# **Coshocton Port Authority Coshocton Collaborative**

### Addendum No. 3 – 19.137

December 11th 2023

**ELECTRICAL DETAILS**

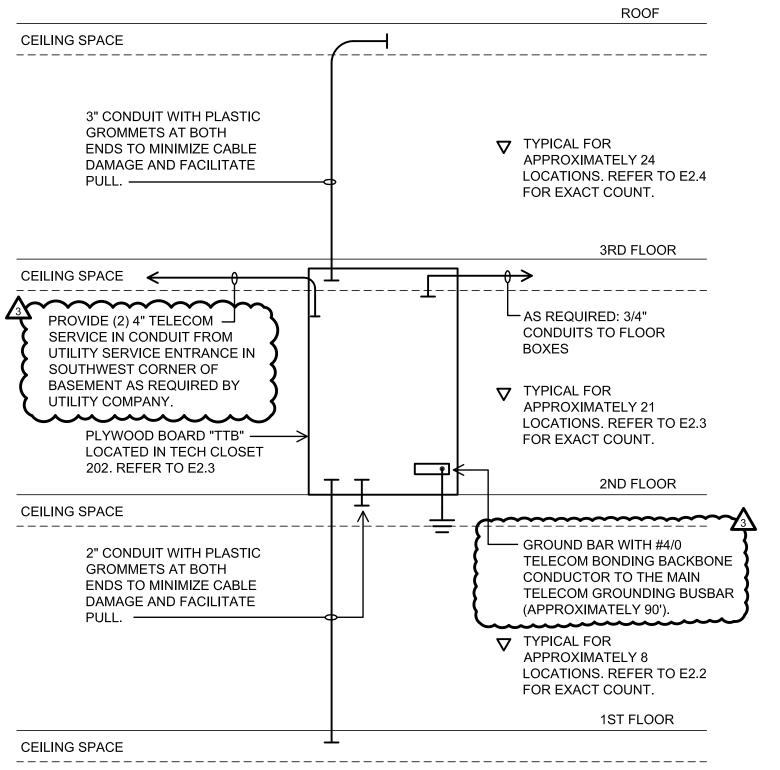
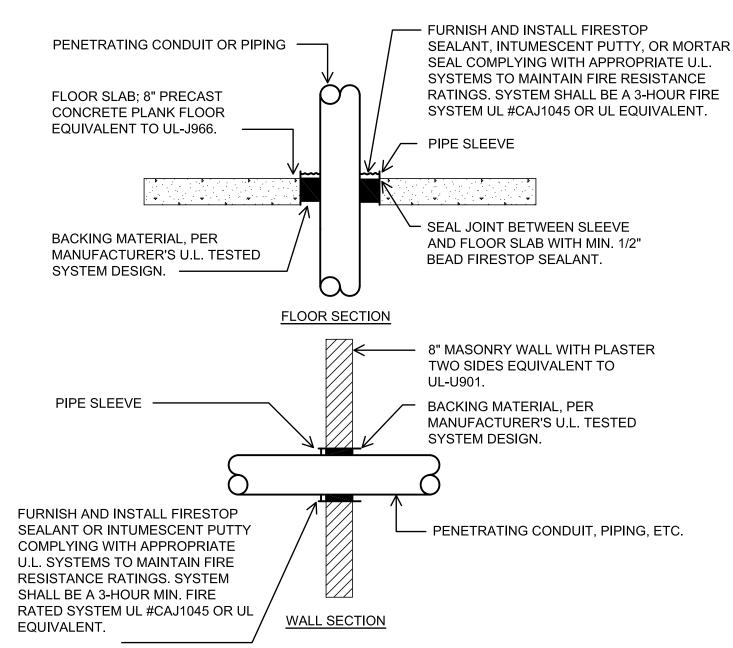
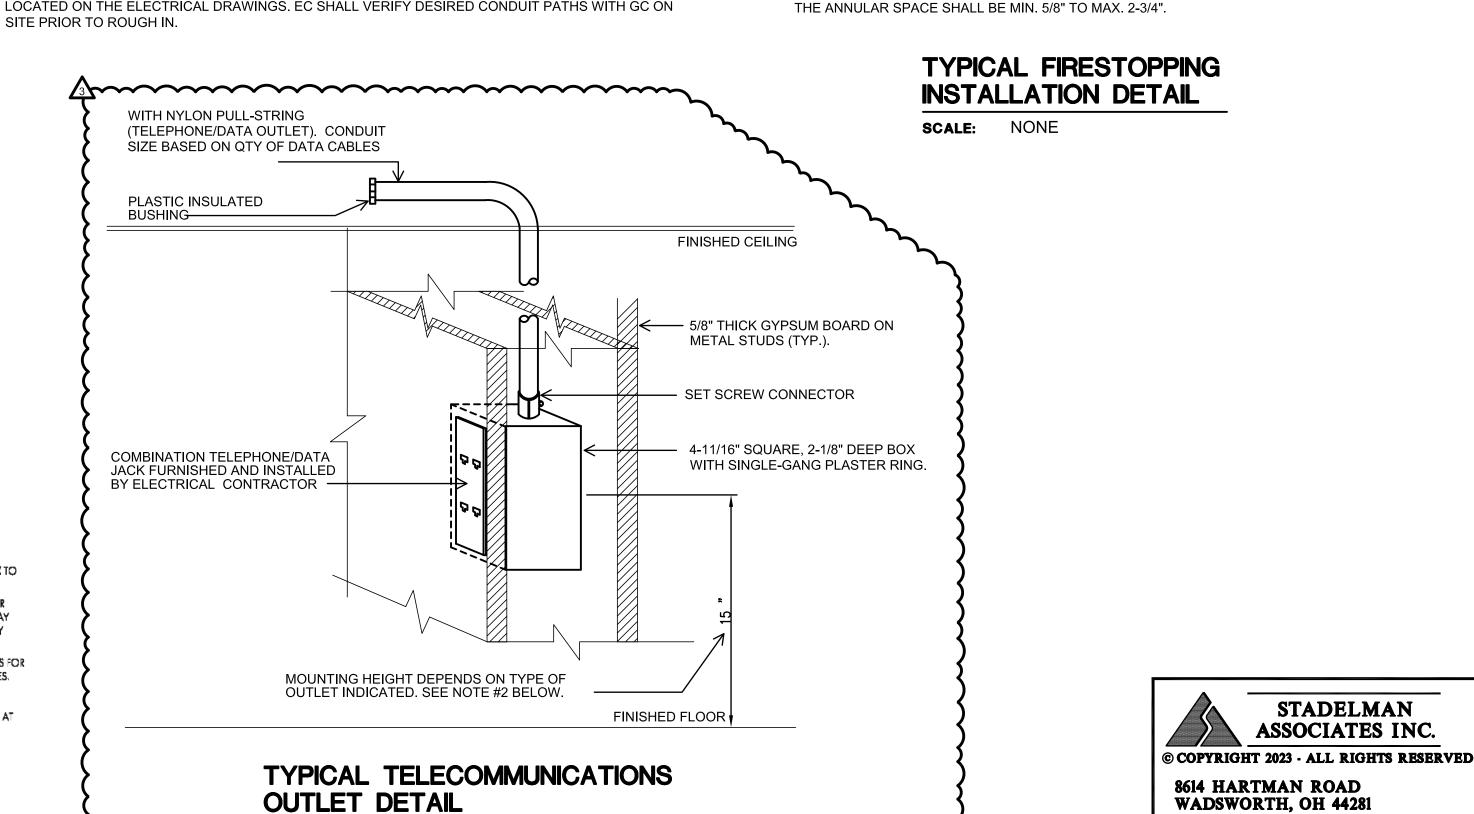
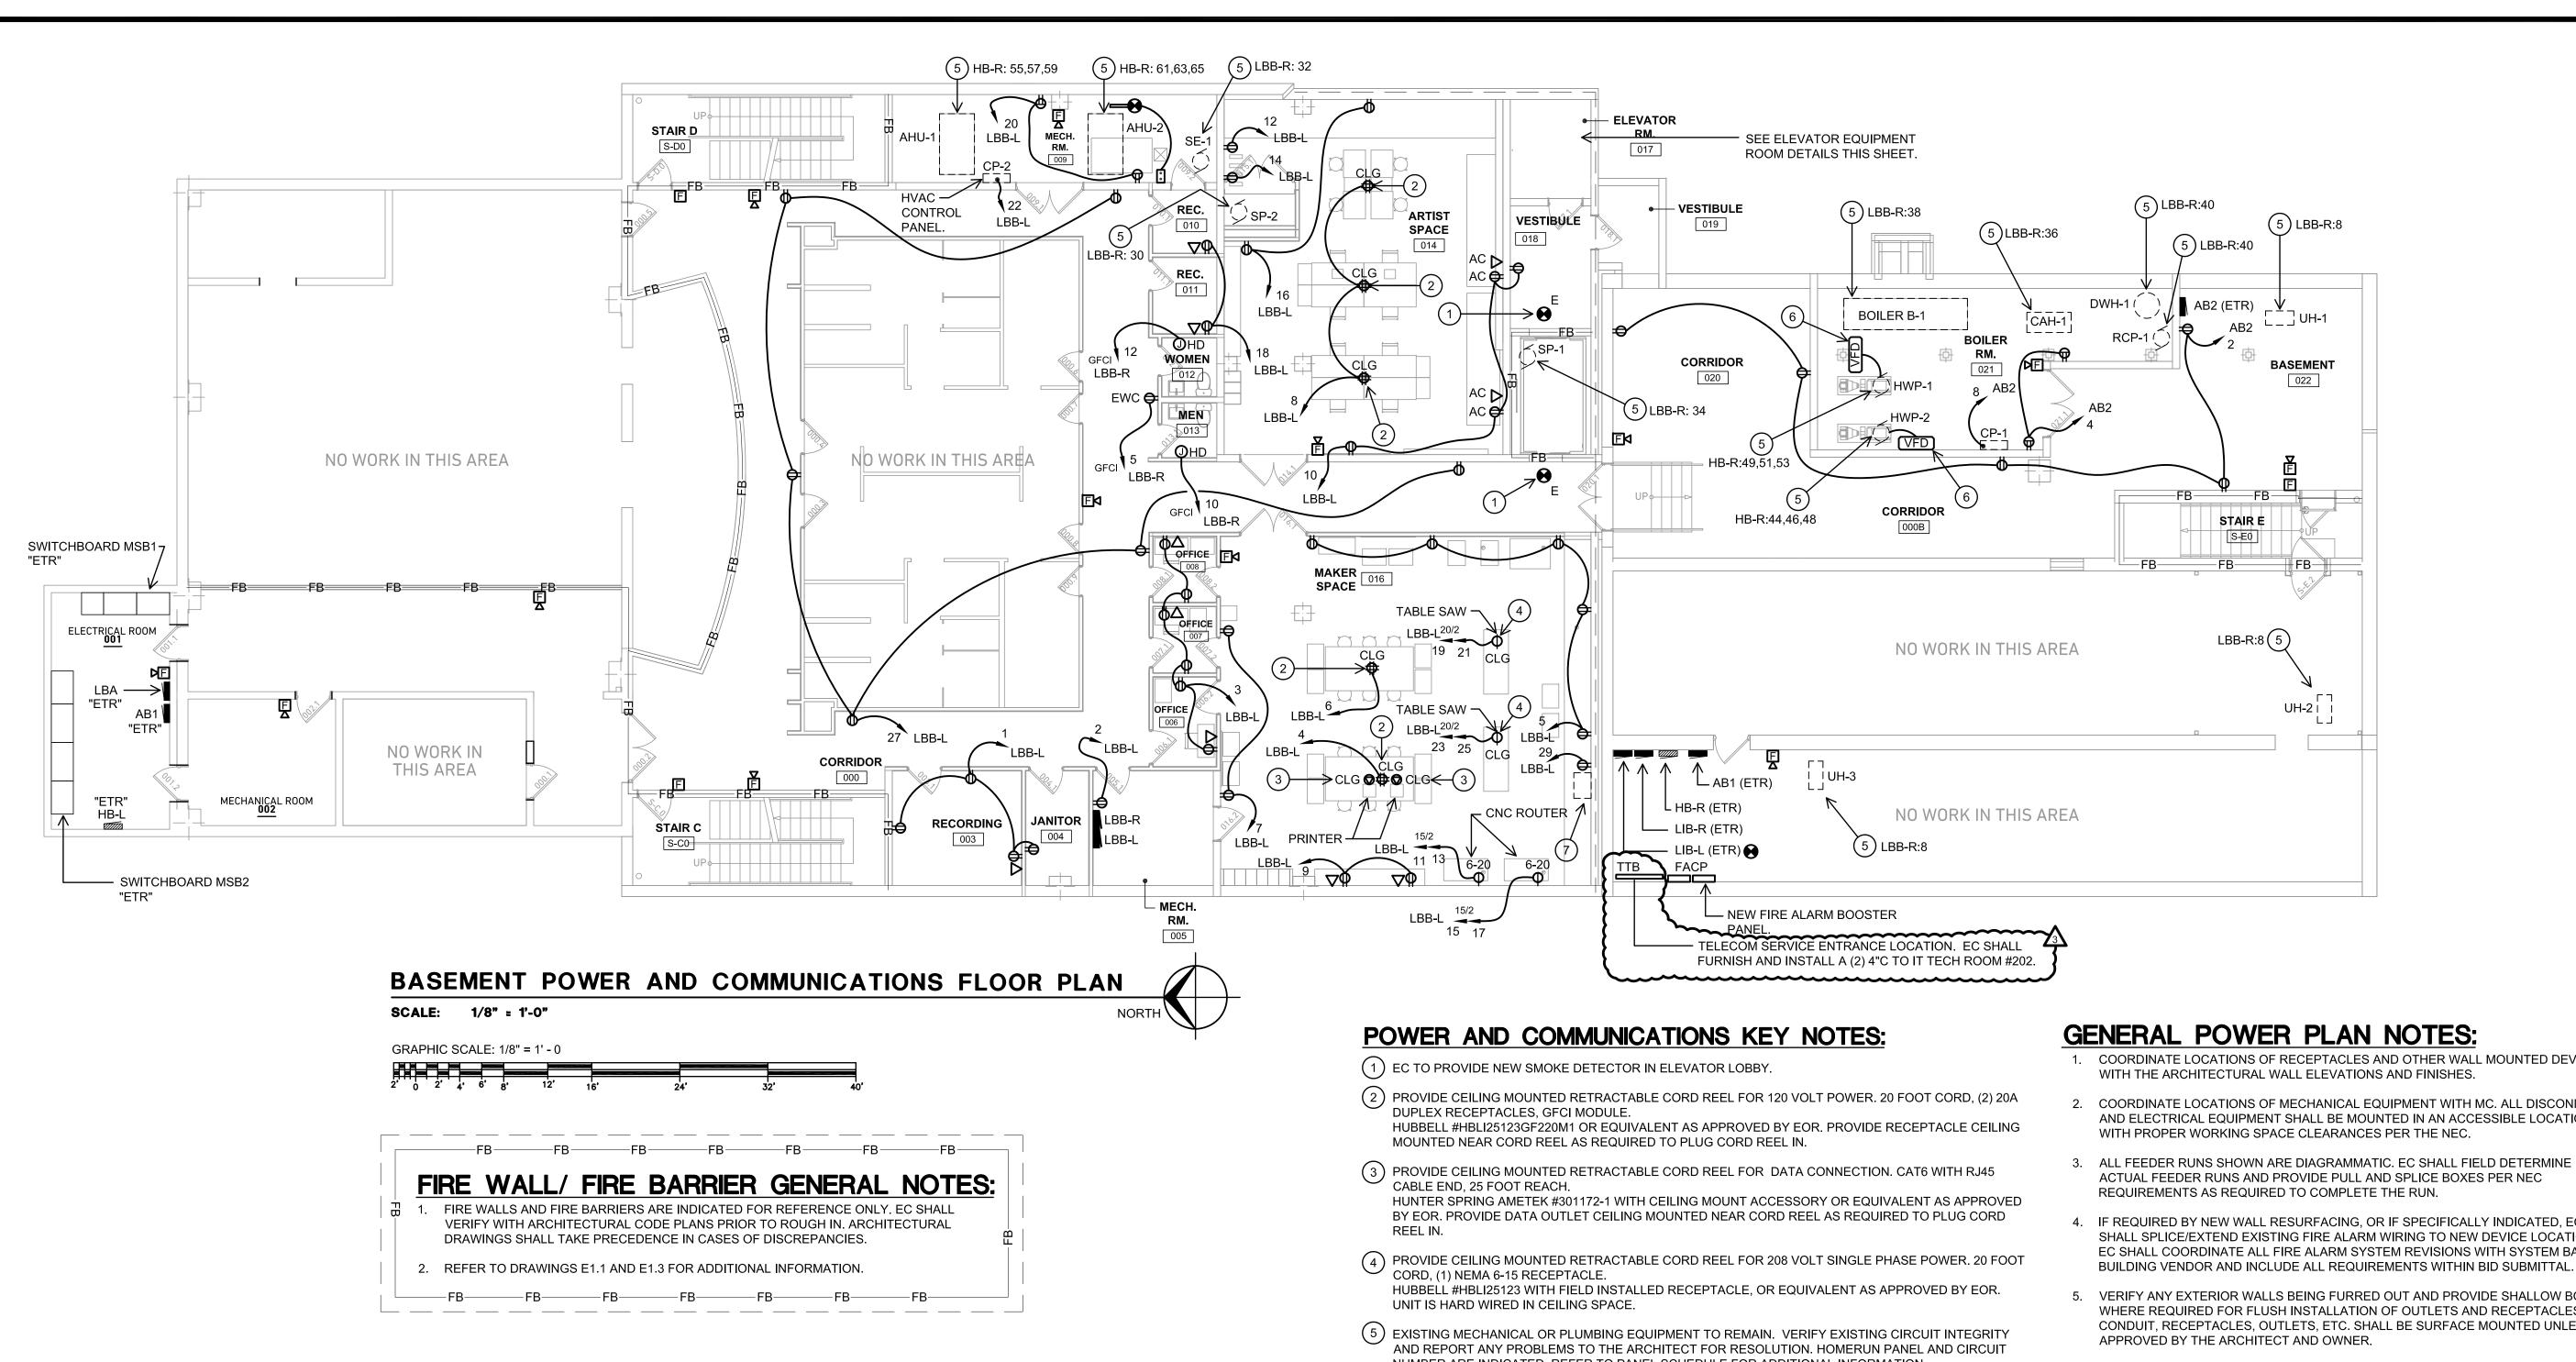
6. Another question has come up regarding spec section 27 1.3 C – "Service entrance pathway empty ducts and raceway from point of Telephone utility connection to building service terminal backboard." Needing to know what size of conduit or conduits and where to be routed outside? No site plan or final location shown for any excavation, back-fill, compaction. The location is shown on the 2<sup>nd</sup> floor for the data backboard.

The Telecommunications conduits (2) 4" are to be installed from the telecom demarcation point in the southwest corner of the basement (adjacent to the FACP) to the IT room on the second floor. See Addendum #3 for revised drawings.
